Re: 19-20-10MO – Roofing – Addendum #2

Re: Addenda to ReRoof & Maintenance Specifications

Re: Addenda to Maintenance Specifications

DETAIL #H-S1

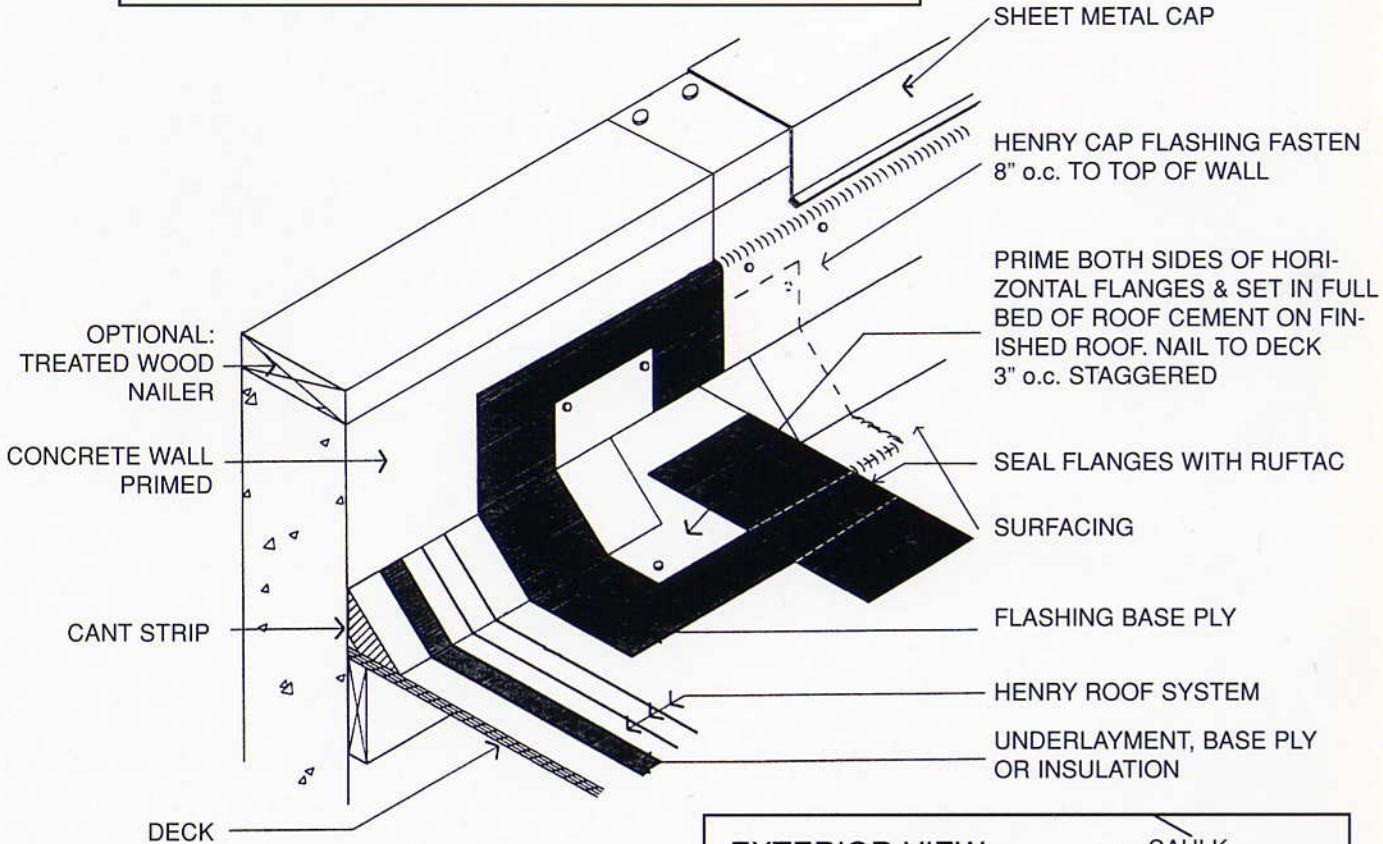
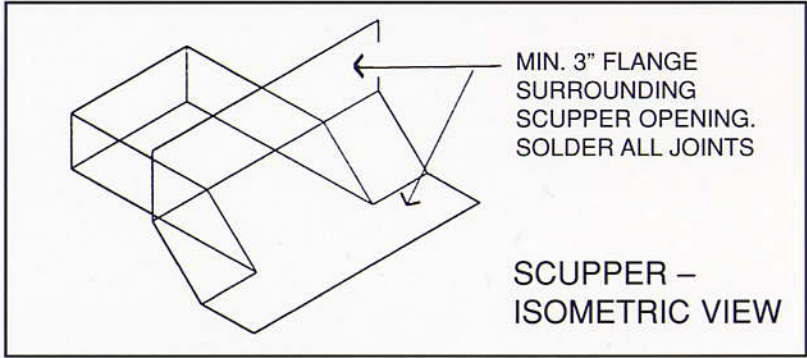
- A. Contractor to furnish and install (14) fourteen 24 g a. Sheet metal scupper & collection box (see attached Diagram) Jurupa USD to install down spout.
- B. Lower drains below roof deck (1) one on building 1500, & (1) one on building 1600.
- C. Install split lead jacks as specified in master specifications to fit field conditions. Install clamp rings and seal with #209 Elastomastic on rod iron fence post (10) ten post, On top of lower roof at the Gym.
